Product Change Notification

110273 - 00

Change Notification #: 110273 - 00
Change Title: Intel® Server Systems SR1600UR, PCN 110273-00, Product Design, Change air duct
Date of Publication: October 11, 2010

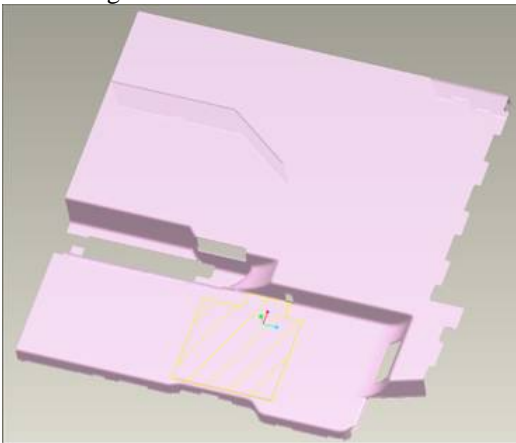
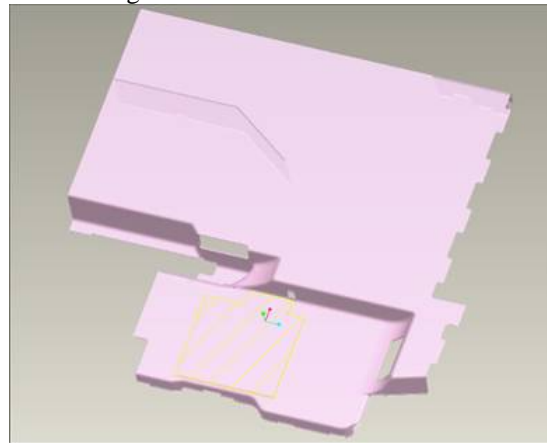
The design of the air duct is being modified to make it compatible with future IO Module designs. The change has been confirmed to meet all thermal and mechanical requirements.
